**Government of India  
Ministry of Railways  
Research, Designs & Standards Organisation  
Manak Nagar, Lucknow - 226 011**

**Modification Sheet No. RDSO/WAM4/186**

1. **Title :** Modification to the protection screen of pinion end shield and air outlet of magnet frame of TAO 659 Traction Motor.

2. **Application :**  
TAO 659 Traction Motor.

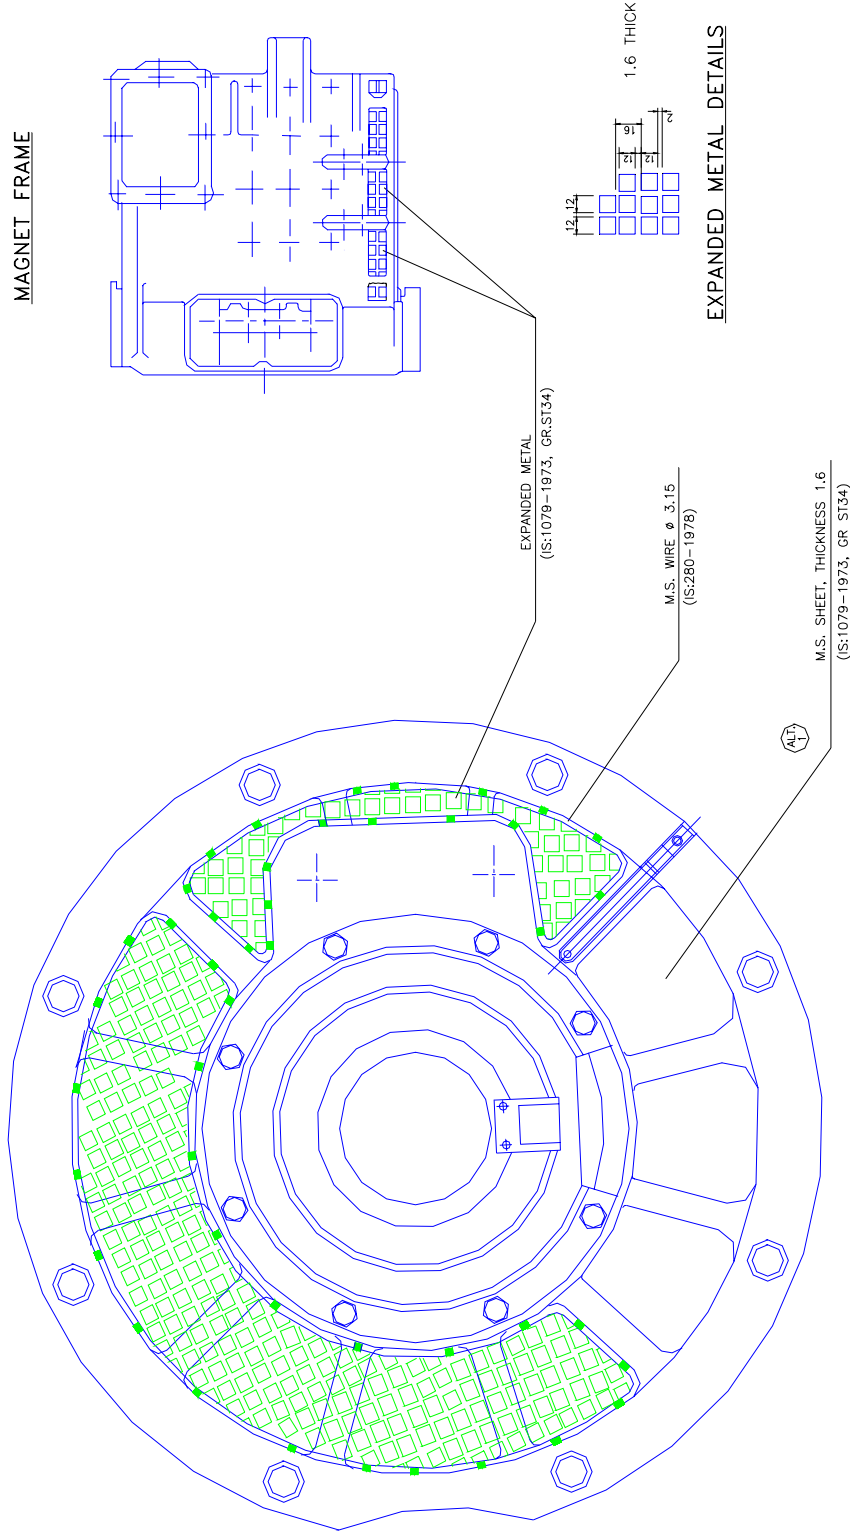
- 4.1 Remove existing expanded metal of mesh size 25x6 mm or punched steel sheet of mesh window size 12 x 12 mm and mild steel sheet of 1.6 mm thick from the pinion end shield and expanded metal of size 50x12.5 mm or 40x12.5 mm from the air outlet of magnet frame.
- 4.2 Dress up the air outlet windows and ribs of pinion end shields.
- 4.3 Cut the piece of the required dimension from the punched steel sheet of mesh window size 12x12 mm for pinion end shield as well as for the air outlet of magnet frame with the help of suitable template as per RDSO Drg. No. SKEL-4269, Alt I.
- 4.4 Cut the piece of mild steel sheet of 1.6 mm thick as per required dimension with the help of suitable template as per RDSO Drg. No. SKEL - 4269 Alt. I.
- 4.5 Weld the above piece of mild steel sheet on the pinion end shield as per RDSO's Drg. No. SKEL - 4269 Alt. I.

**4.6** Tack weld the punched steel sheet as per clause 4.3 above of the required sizes on the pinion end shield as well as on the air outlet of the magnet frame as per RDSO DRg. No. SKEL - 4269 Alt. I.

**4.7** After tack welding the punched metal sheet on pinion end shield, a stiffening steel wire of dia 3.15 mm should be stagger welded with pinion end shield along with the punched steel sheet.

1		LOWER OPENING HAS BEEN BLOCKED	JAN.95
STATUS	ALT.	REF No.	DESCRIPTION	DATE
				Bygo Klemmer

**5.1** Mild steel sheet of 1.6 mm thick of required size as per IS 1079-1973 grade ST-34.

**5.2** Punched mild steel sheet of mesh opening size 12 mm x 12 mm (outer window size 14x14 mm), 1.6 mm thick as per IS 1079-1973 Grade ST.34.

**5.3** Steel wire of dia 3.15 mm half hard as per IS 280-1978.
